Appl. No.: 10/737,040  
Amdt. dated 06/22/2005  
Reply to Office action of March 2, 2005

### **REMARKS/ARGUMENTS**

Patent Application Publication Nov. 18, 2004 Sheet 1 of 16 US 2004/0227044 A1

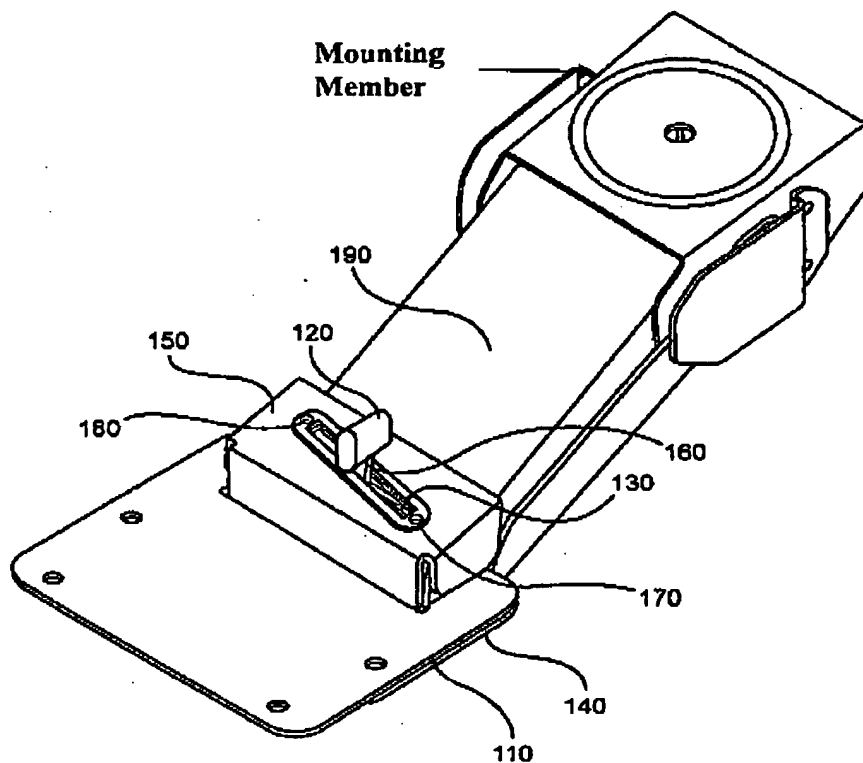
The Examiner also objected to the drawings because they allegedly “fail to show ‘auxiliary support mechanism’, ‘a mounting member’, ‘a second elongated slot’, ‘an acute angle with respect to the substantially parallel slot’, and ‘a spring means mounted on the third member in a manner effective to urge the third member into an upward position’. The Applicant respectfully traverses this objection.

The Examiner alleges that the drawings of the above-identified application fail to show an “auxiliary support mechanism”. The Applicant respectfully traverses the Examiner’s objection and submits that Figure 1 shows an ‘auxiliary support mechanism’. In particular, the Applicant notes that paragraph 39 states “[t]urning to FIG. 1, the adjustable support mechanism 100”. Thus the above-identified application illustrates an ‘auxiliary support mechanism’.

The Examiner also alleges that the drawings of the above-identified application fail to show 'a mounting member'. The Applicant respectfully traverses the Examiner's submits that one of ordinary skill would recognize the structure in Fig. 1 attached to the end of structure bearing point 190 away from box member 150 to be a mounting member. See also the Applicant's earlier U.S. Patent No. 5,924,664 for further elucidation of what those of ordinary skill understood the term "mounting member" to mean in the context of an adjustable support mechanism.

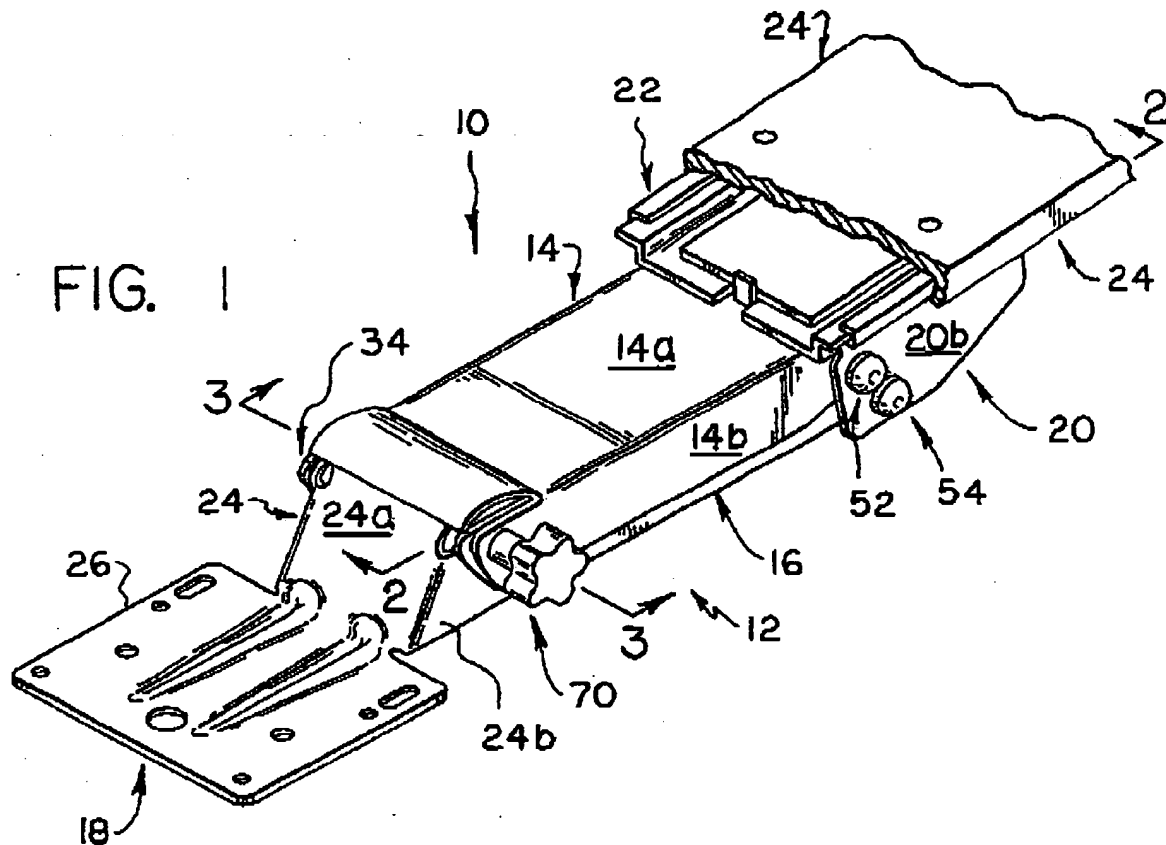
The Examiner alleges that "Pangborn et al. teaches an auxiliary shelf adjustment mechanism comprising: a first member (20, 24) having a plurality of surfaces mounted on an end of an auxiliary support mechanism distal to the mounting member of the auxiliary support mechanism, . . . ." Office Action at 5. While this assertion's use of the terms of the claim might be consistent with some undefined dictionary, it is inconsistent with the above-identified application. For this reason, the Applicant respectfully submits that the Examiner's construction of the claim is not reasonable.

Thus, we turn to examine the Pangborn patent to ascertain what part, or parts, connect Pangborn's auxiliary support mechanism to a primary support. From Fig. 1 of Pangborn, it is obvious that the mounting member of Pangborn's auxiliary support mechanism is the structure labeled 20. The text of Pangborn, e.g., "second or rear ends pivotally connected to a second element 20, which is adapted for mounting on a suitable base, such as may be defined

Because Pangborn element 20 is the mounting member, element 20 cannot be distal to the mounting member. Thus, the Examiner has not made a *prima facie* showing that Pangborn discloses the claimed subject matter. For this reason, the present rejection must be withdrawn.

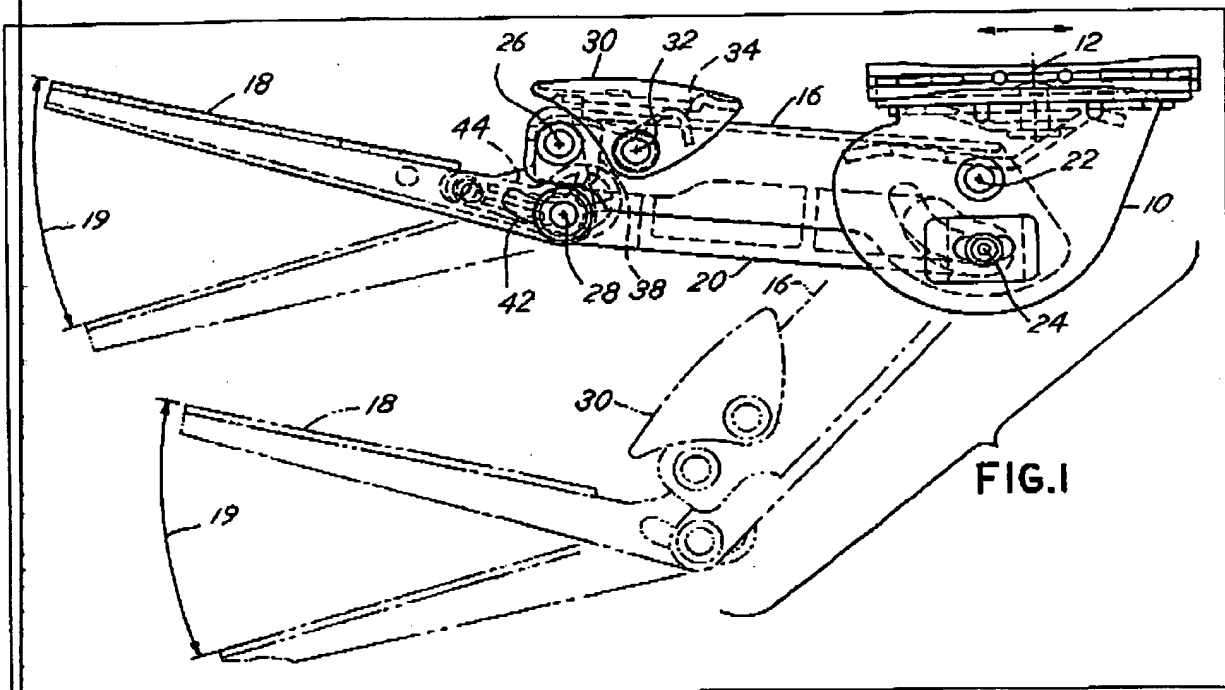
The Examiner alleges that "Hudson teaches an auxiliary shelf adjustment mechanism comprising: a first member (10) having a plurality of surfaces mounted on an end of an auxiliary support mechanism distal to the mounting member . . . : Office Action at 6. An implicit premise in the Examiner's assertion is that first member (10) is not the mounting member.

However, a review of the Hudson patent establishes that this premise is false. Specifically, as shown in Fig. 1 of Hudson, first member (10) is the member that connects the auxiliary shelf mechanism to the main surface, *i.e.*, first member (10) is the mounting member. Hudson confirms this analysis of Fig. 1 by stating: "slide bracket assembly 10 which is slidably mounted in a bracket (not shown) that is mounted to the underside of a work surface, desk or platform," Col. 2, lns. 51 – 54.

Because Hudson's first member 10 is the mounting member, first member 10 cannot be distal to the mounting member. Thus, the Examiner has not made a *prima facie* showing that Hudson discloses the claimed subject matter. For this reason, the present rejection must be withdrawn.
